Addendum No. 1 – Job 101243

City of Jonesboro

Jonesboro Marion Berry Pkwy. Ped. Impvts. (TAP-24) (S)

The Plans, Specifications, and Contract Documents for this Project shall be amended as follows:

DATE REVISED	DATE FILMED	DATE REVISED	DATE FILMED	FED. ROAD DIST. NO.	STATE	FED. AID PROJ. NO.	SHEET NO.	TOTAL SHEETS
				6	ARK.			
10/15/2026				JOB NO.		26681.03	38	65

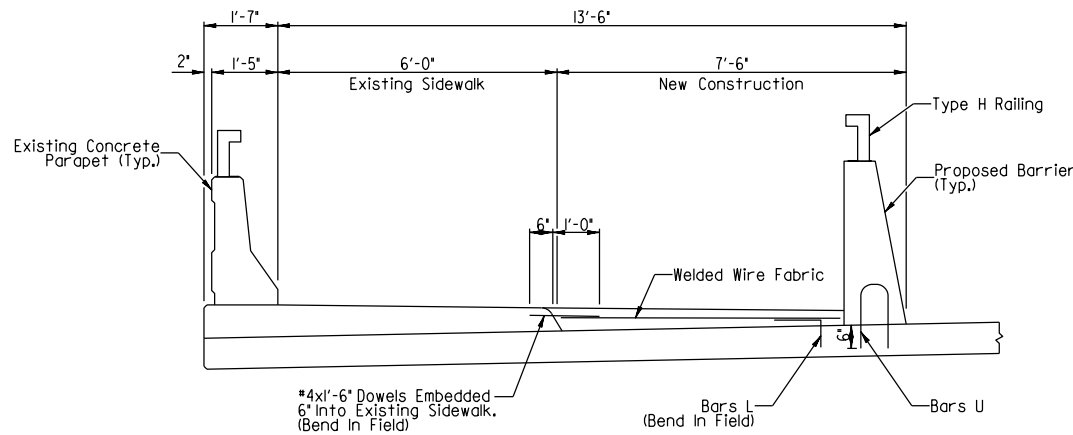
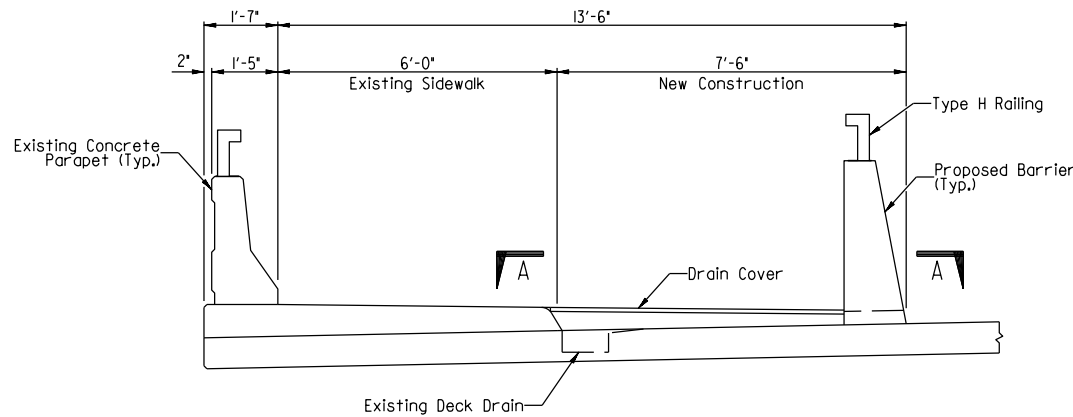
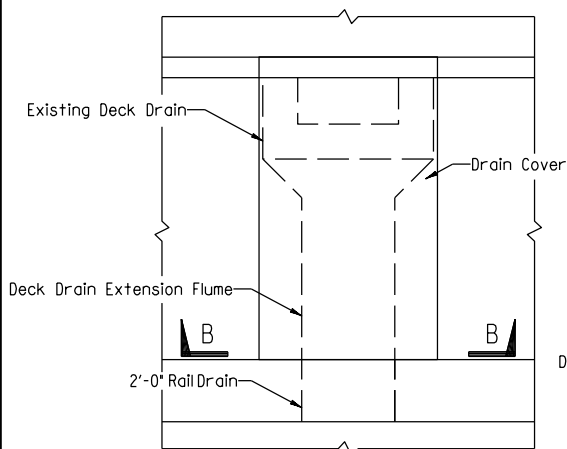
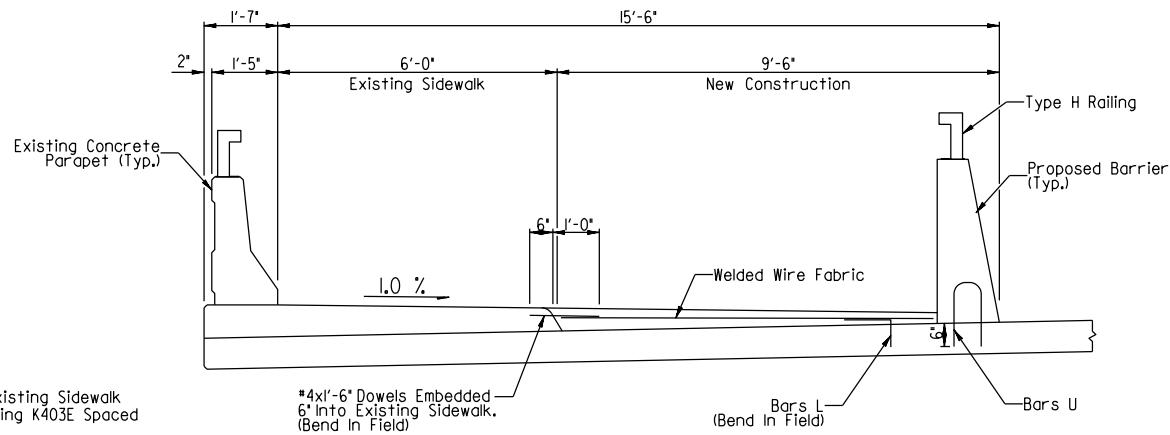
6. Plan sheet 38 was REVISED to change the concrete required for the sidewalk from UHPC Concrete-Sidewalk to Class S(AE) Concrete-Sidewalk. Please replace these sheets with the revised sheets attached.

10. Sheet E-5 General Note 7 requires all conduit for lighting on the barrier wall to be concealed in concrete, and Sheet 38 refers to the lighting plans for conduit installation. Please confirm that electrical rough-in is to occur in the barrier forms prior to each pour, and whether expansion fittings are required at bridge deck joints.

14. The Summary of Quantities lists 1 EA Trench Grate with no bid line. Sheets 36 and 38 show existing deck drain extensions, a flume and steel drain covers. What is the trench grate? Where is it? What item pays the deck drain?

Answer: Refer to detail 1 on sheet E-10. Any expansion joints will require expansion fittings.

Answer: The "Trench Grate" item was changed to "Drain Cover" and added to the Unit Bid Schedule. Drain cover location is shown on sheet 36 and this pay item shall cover all work necessary to drain water from the roadway to the existing deck drain.

Answer: The UHPC designation is changed to Class S(AE) Concrete-Sidewalk. A Special Provision is provided for use of the new mix design with smaller aggregates. The Class S(AE) Concrete-Sidewalk pay item shall cover all concrete to be used for the sidewalk on in the limits of the bridges. The concrete for the sidewalk outside the limits of the bridge shall follow the requirements for the Concrete Walks pay item.

DATE REVISED	DATE FILMED	DATE REVISED	DATE FILMED	FED. ROAD DIST. NO.	STATE	FED. AID PROJ. NO.	SHEET NO.	TOTAL SHEETS
				6	ARK.			
10/15/2026				JOB NO.		26681.03	39	65

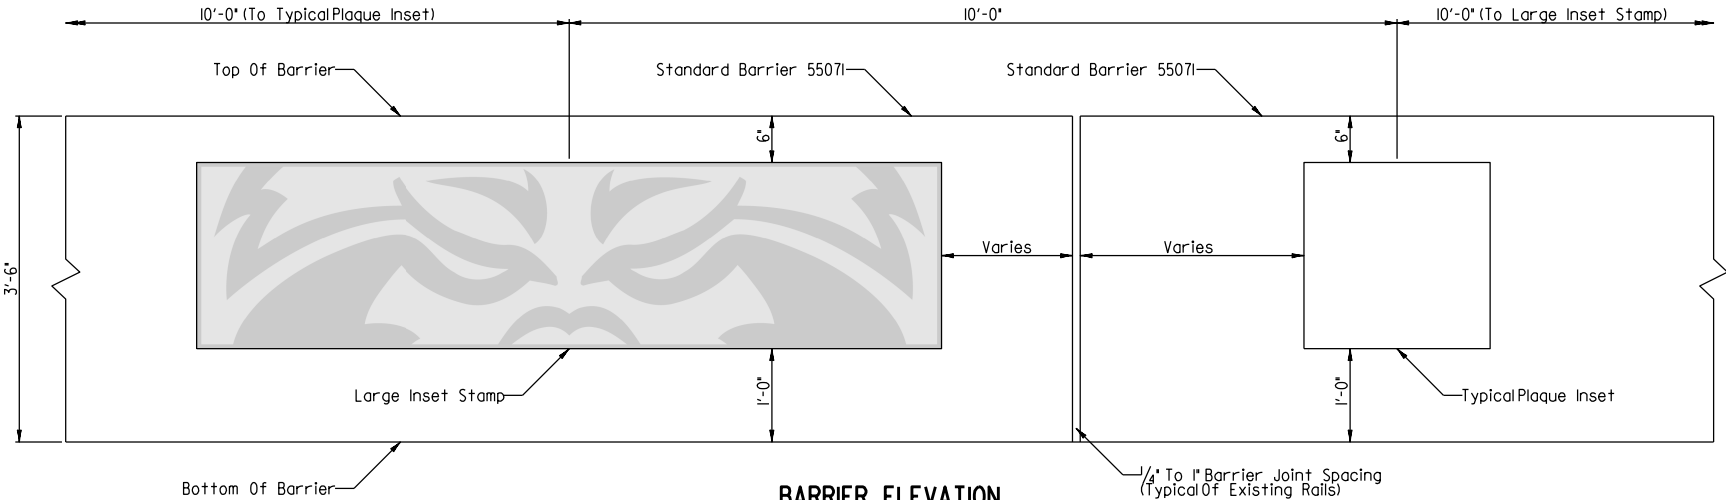
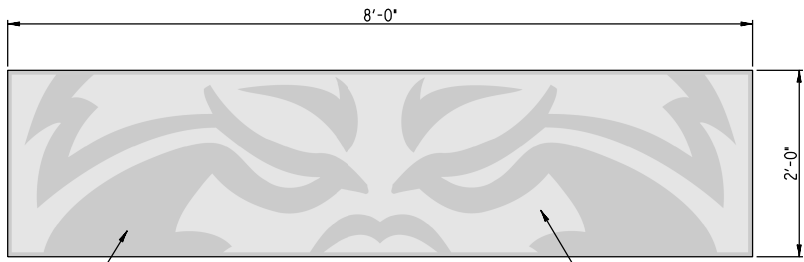
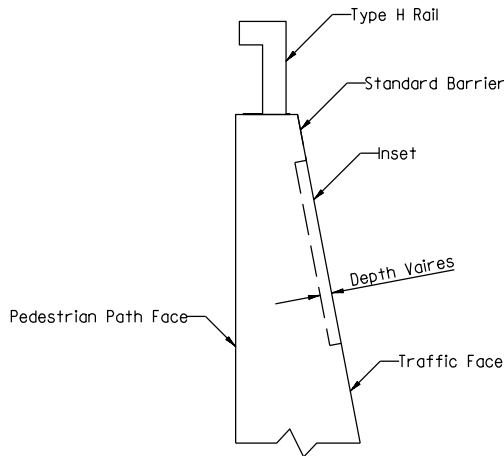
7. Plan sheet 39 was REVISED to change the wording “steel insets” to “plaques.” Please replace these sheets with the revised sheets attached.
8. Plan sheets E-0 – E-8 and E-10 were REVISED to modify the type A fixture to be RGBW, to add stationing, and to modify the type B fixture to in accordance with the Buy America – Construction Materials Special Provision. Please replace these sheets with the revised sheets attached.

1. It appears in the drawings on Page 39 that the only areas of the existing steel that will receive field coating is the Type H Rails. Is it correct that the only existing structural steel receiving coating are the H Rails? Has the existing coating been tested for lead or other heavy metals? Required surface preparation standard and containment over the railroads?

12. Sheet E-0 requires Type A fixtures to be centered over the ASU logo plaques (Item 54, Sheet 39). Please provide plaque stations, or confirm that the 20'-0" on-center spacing on Sheet E-5 governs, so that cast-in junction boxes can be located.

13. There is no written spec for the plaques on this job. Not stated anywhere: plate material or gauge? How the artwork is applied? Anchoring method? Who supplies the final artwork? Whether the logo needs licensing approval? What the pay item for plaque price includes? Does the plaque require a 3D style look?

Answer: Yes, the only existing structural steel receiving coating are the H rails. The bridges were constructed in 2010. The existing plans called for galvanized steel, and no test for lead or other heavy metals have been performed on the existing conditions. Required containment shall be verified by the contractor.

Answer: Plaque stations are provided on sheet 39.

Answer: The plaque should be 0.25 in. cast aluminum. The artwork should be shop painted. The anchoring method should be a tamper-proof method proposed by the contractor. Digital artwork files will be provided as needed to the awarded contractor. There are no anticipated issues with licensing; Arkansas State University will work directly with the manufacturer to grant a waiver and provide artwork once the contract is awarded. The pay item for plaques shall provide full compensation for material, anchoring system, and all required items, equipment, and labor necessary for installation. The plaque should not have a 3D look it should be flat painted. Painting notes on sheet 39 indicate a steel inset; this wording is changed to say "plaques".

DATE REVISED	DATE REVISED	FED. RD. DIST. NO.	STATE	JOB NO.	SHEET NO.	TOTAL SHEETS
10/15/2026		6	ARK.	101243	E-1	
ELECTRICAL DEMOLITION PLAN

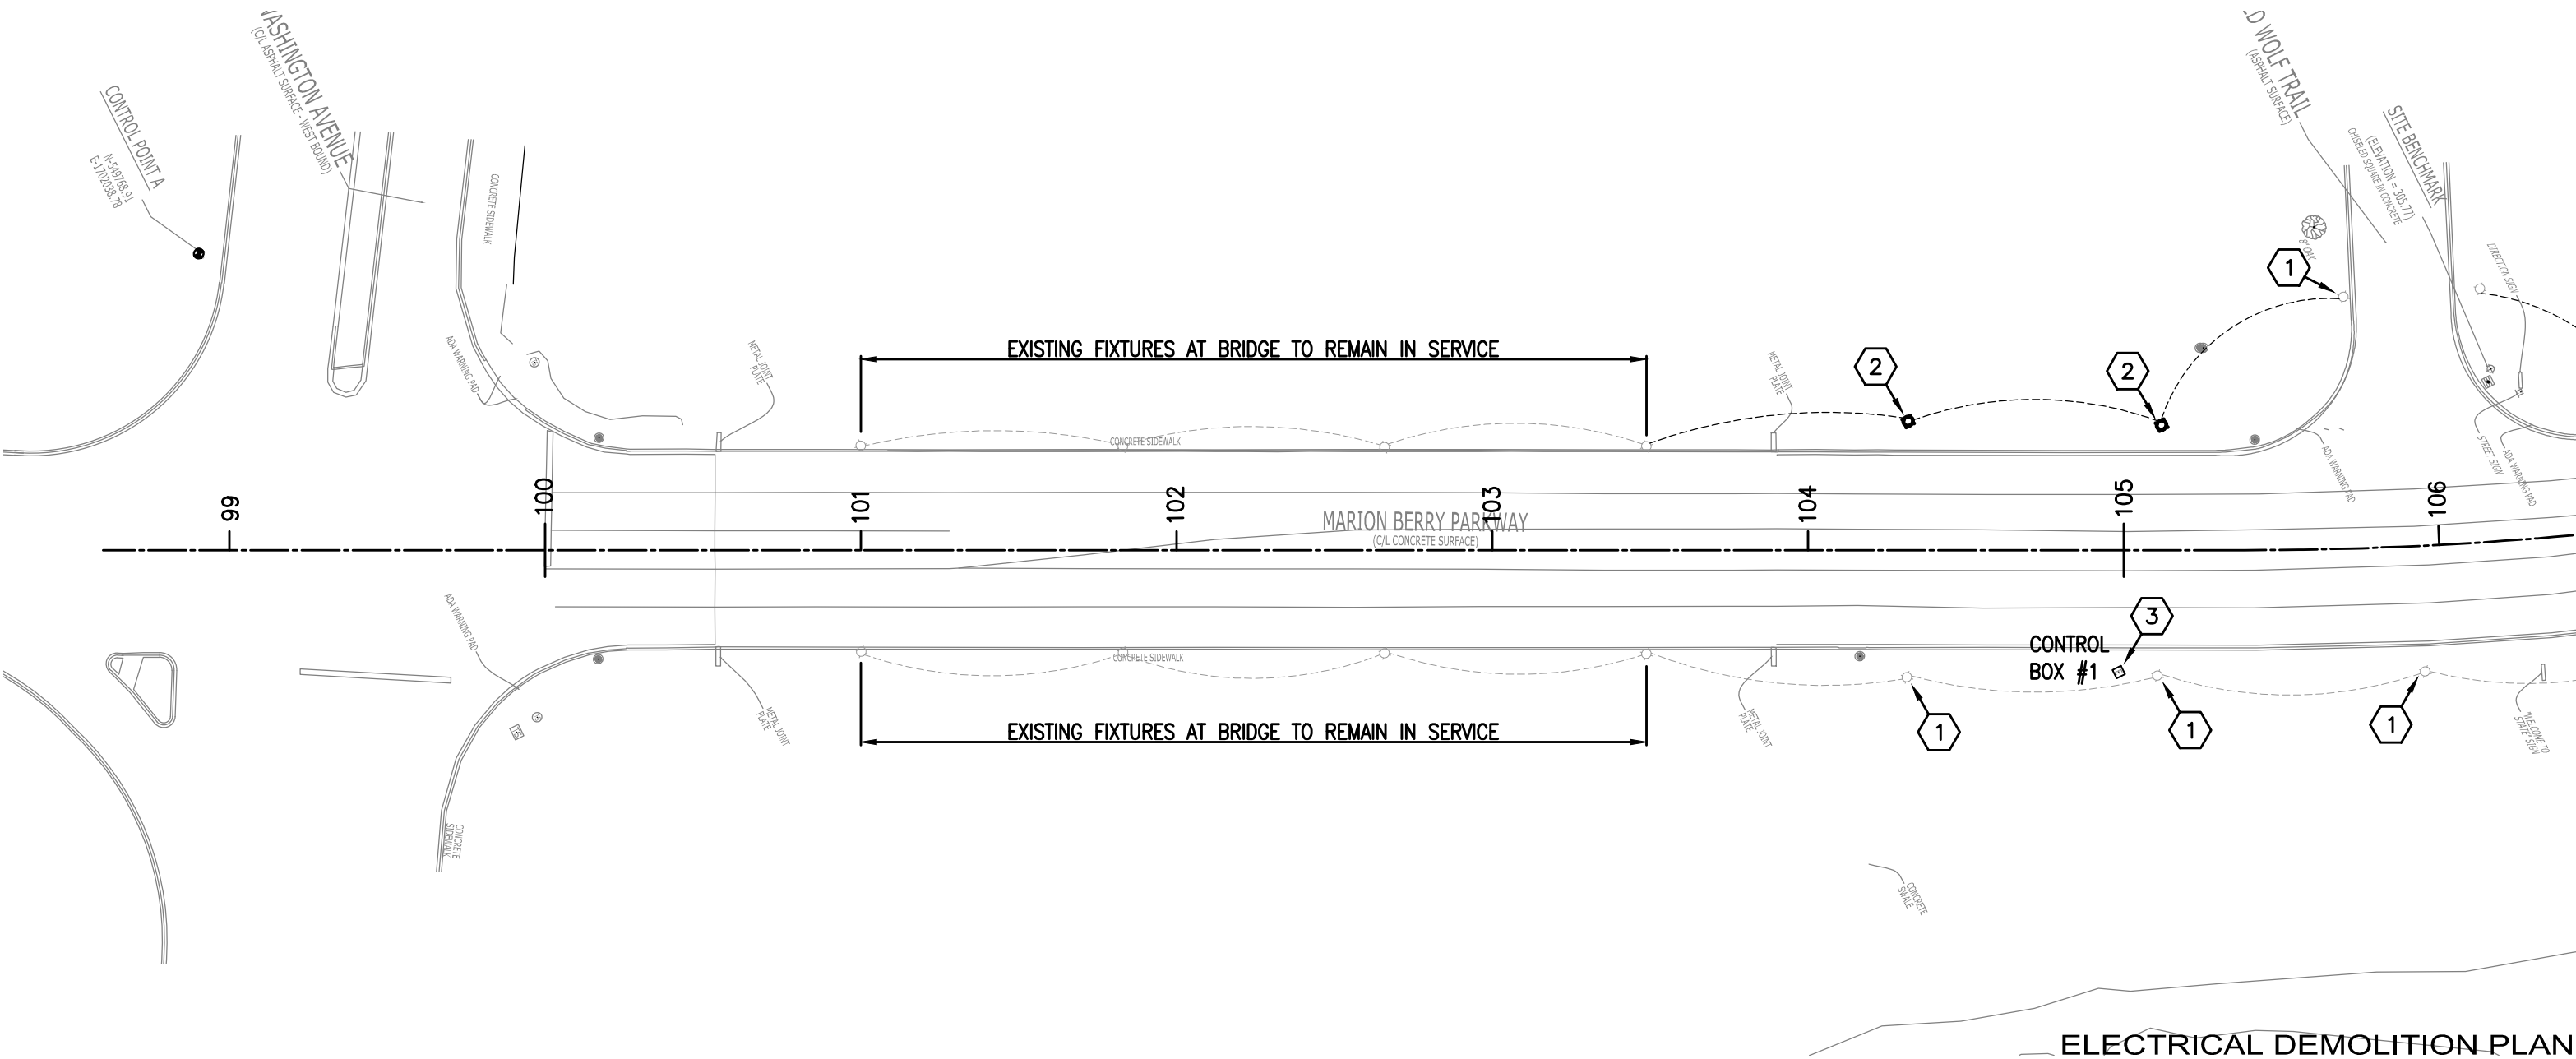
2. Sheets E-1 to E-4 show 17 poles to be removed and retained and E-5 to E-8 show 18 to be reinstalled on new auger bases. Item 47 is 14 EA. Please confirm the count.

7. Please provide the manufacturer, model, voltage, and available spare breaker positions for the existing switchgear ("Control Box #1," Sheet E-1, Key Note 3), and confirm the routing and lengths of the 2#6+1#6G and 2#4+1#4G feeders to each bridge, which are not dimensioned.

Answer: The number of existing poles to be retained and reinstalled is to be 17.

Answer: Electrical drawings note for the contractor to verify existing conditions. Spare breaker provisions have been verified. Means/methods of construction are not shown on design drawings.

DATE REVISED	DATE REVISED	FED. RD. DIST. NO.	STATE	JOB NO.	SHEET NO.	TOTAL SHEETS
10/15/2026		6	ARK.	101243	E-5	
ELECTRICAL LIGHTING PLAN

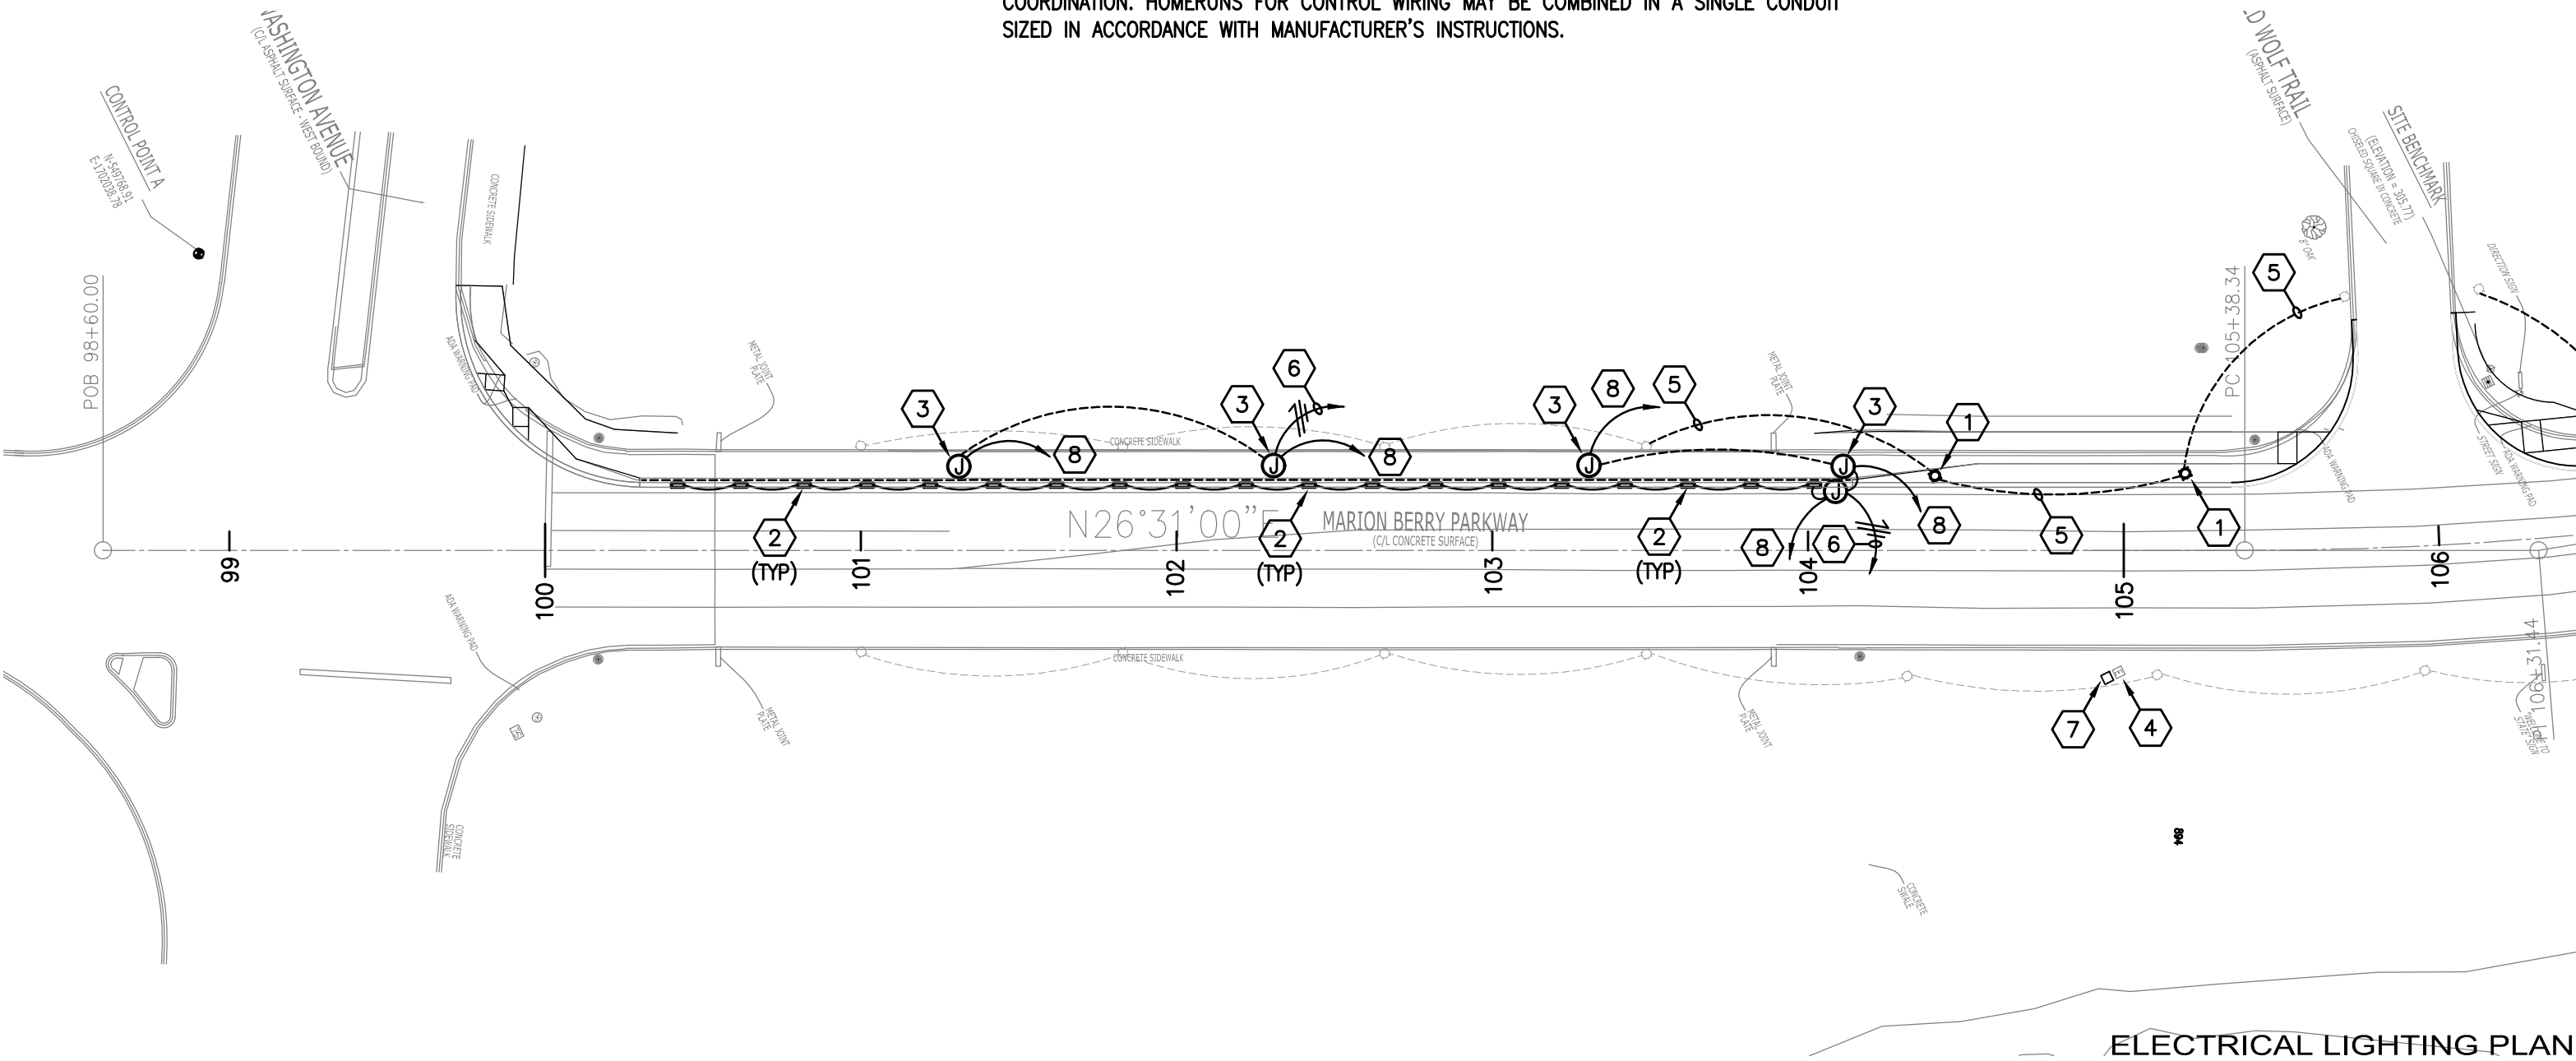
6. No pay item covers the control cabinet assembly, the new 20A/1P breaker in the existing switchgear (E-5 Key Note 6; E-6 Key Note 5), or the bridge feeders. Please confirm which item(s) this work is incidental to, so that Deductive Alternate 2 deducts correctly at base-bid unit prices as required by the bid form.

Answer: The control cabinet, breakers, lighting controls, and transformer/receptacle are to be furnished under the added pay item 40. Bridge feeders are included in items 41 and 44.

DATE REVISED	DATE REVISED	FED. RD. DIST. NO.	STATE	JOB NO.	SHEET NO.	TOTAL SHEETS
10/15/2026		6	ARK.	101243	E-10	
ELECTRICAL DETAILS

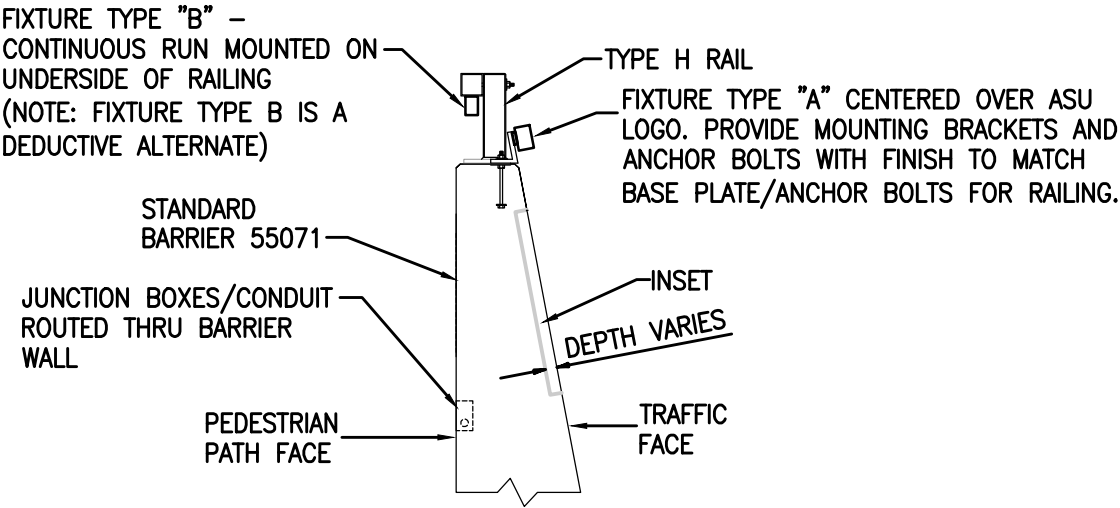
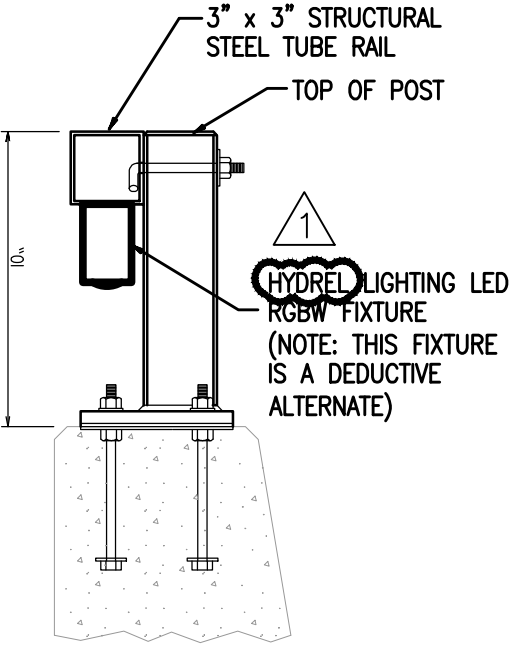
4. The Type A fixture (Alights LIN-3-SP-3'-LS-40K-90CRI-U-WG-MOUNTING-B) is a static 4000K fixture; however, Sheet E-0 Fixture Schedule Note 4 requires RGBW power supplies and controllers for all fixtures, and Sheet E-10 Control Cabinet Note 4 requires programming of Type A and Type B fixtures. Please confirm whether Type A is static white or RGBW/DMX-controlled.

5. Sheet E-10, Detail 3 (control cabinet, ART 500 DMX controllers, 1kW transformer, concrete base, spare conduits) notes that controls for Type B fixtures are a deductive alternate. Please confirm whether the control cabinet assembly is required in the base bid if Deductive Alternate 2 is accepted.

Answer: The Type A fixture should be (Alights LIN-3-SP-3'-LS-RW-90CRI-U-WG-MOUNTING-B). Fixture Type A shall be RGBW/DMX controlled. Contractor shall coordinate with supplier to ensure 4000k white is provided.

Answer: The control cabinet is required in the base bid and is necessary for the type A fixtures.
